Common Departures on Tariff Meter Communication (TMC) Infrastructure

iii. Location of Main Switch

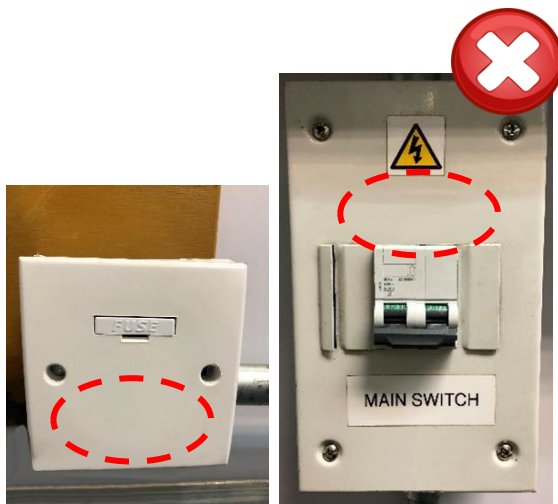
Main switch for TMC equipment is not installed within the same meter room.

Main switch for TMC equipment should be installed within the same meter room.

2. Plastic Engraved Labels

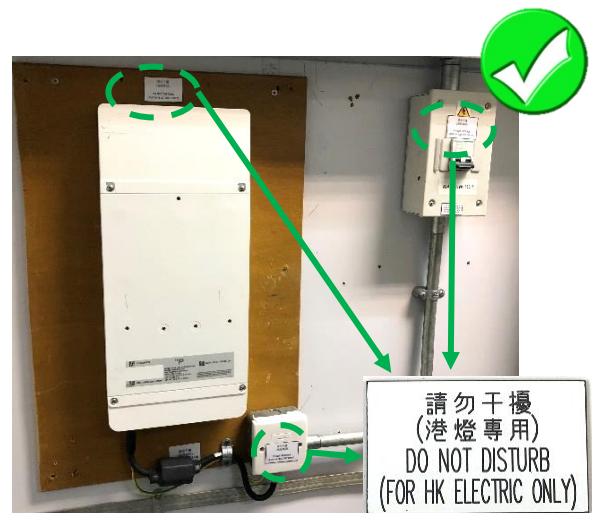
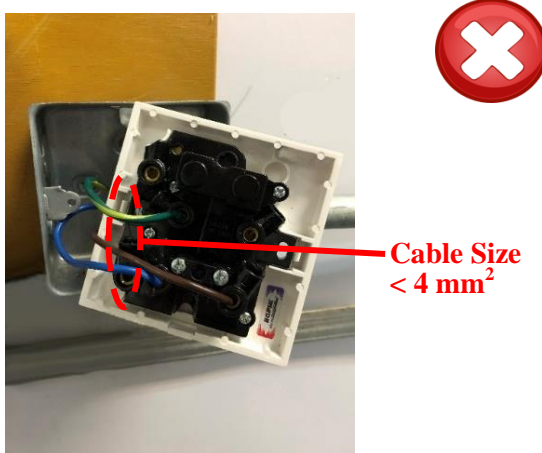
Plastic engraved labels with the words “DO NOT DISTURB (FOR HK ELECTRIC ONLY) 請勿干擾 (港燈專用)” are not provided on wooden board, fused connection unit and main switch of TMC equipment.

The plastic engraved labels should be provided on wooden board, fused connection unit and main switch of TMC equipment.

3. Cable Size

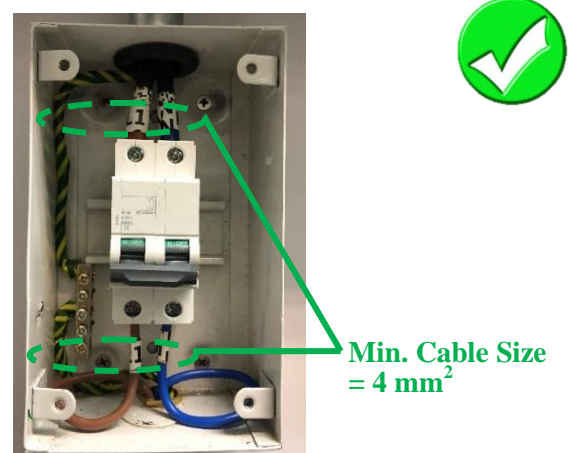
The wires amongst the main switch for TMC equipment, fused connection unit and the unmetered lateral/ rising mains less than 4mm² Cu PVC/PVC cable are not allowed.

The wires shall be of at least 4mm² Cu PVC/PVC cable.

4. Front Clearance for TMC Equipment

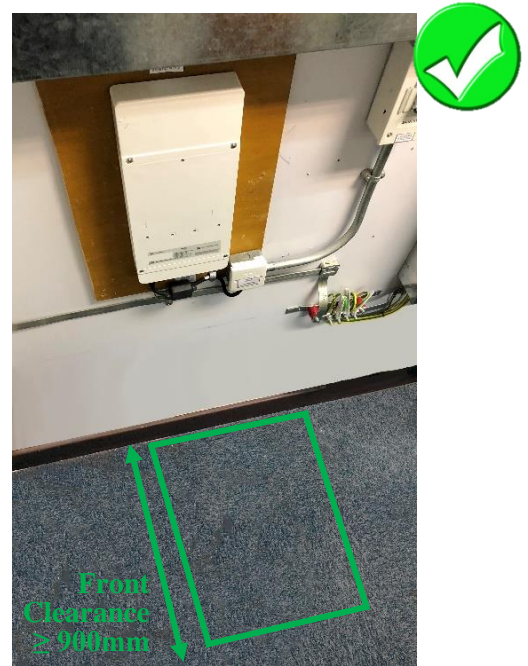
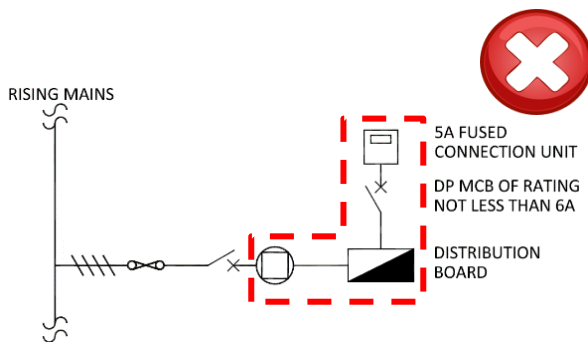
Front clearance of the wooden board less than 900mm is not allowed.

Minimum space of 900mm must be maintained in front of the wooden board for free access and as working space.

ii. Facilities in the Customer Main Switch Room

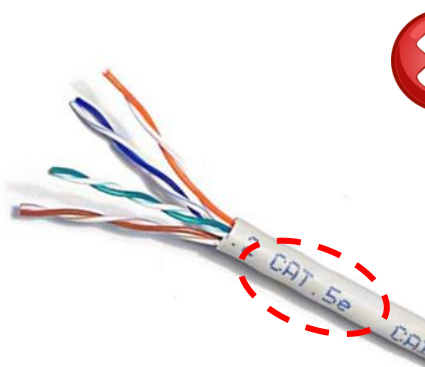
GI conduit from the TMC termination box, junction box and Cat. 6 STP communication cables are not installed for TMC equipment.

GI conduit from the TMC termination box, junction box and Cat. 6 STP communication cables shall be installed on the wooden board for TMC equipment in the customer main switch room.

i. Type of Communication Cables

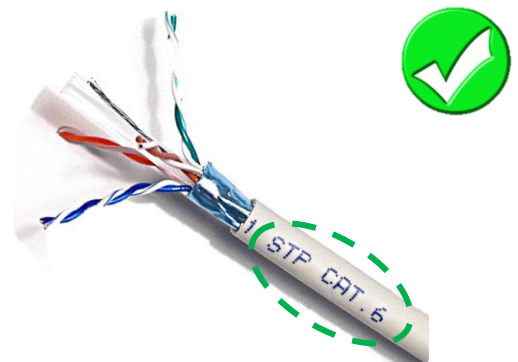
Incorrect type of communication cable from the TMC termination box at the customer main switch room up through to the junction box on the wooden board for TMC equipment is not allowed.

Cat. 6 STP (Shielded Twisted Pair) communication cables shall be used.
